25 Gbd Stressed RX Sensitivity specs and methodology for 802.3ca

- background on Cmt. 418 SRS proposal

802.3ca TF meeting, Vienna

D2.0 - Comment #418

Existing SRS Specifications

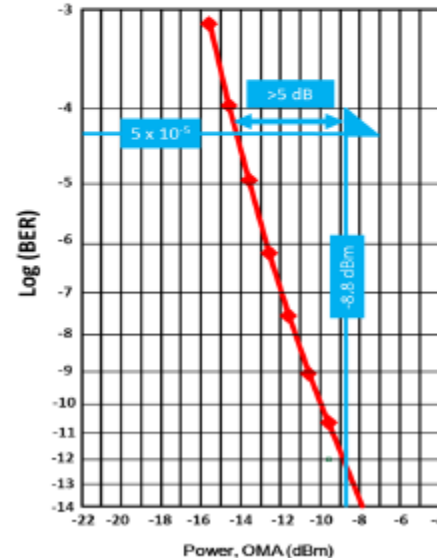
- From Tamura - Slide 5
- It appears that 25GBASE-SR/LR/ER were aiming at a breakout matching specification
- This study asserts that VECP, J2, & J9 methodology of SRS are more severe than any of the specs on the previous slide, which includes all of the 25GBASE-SR/ER/LR applications

- 802.3ca has no 25Gbd breakout matching requirement
- From Tamura, it appears that our current .3ca method of SRS measurement based on 100GBASE-LR/ER SRS is more severe than SRS based on 25GBASE-SR/LR/ER
- Changing stressed receiver sensitivity methodologies at this point could require a substantial amount of work and potential new measurements (new eye masks & J4 measurements)
- It's recommended that we retain our current D2.0 VECP, J2, J9 stressed receiver sensitivity methodology and specification
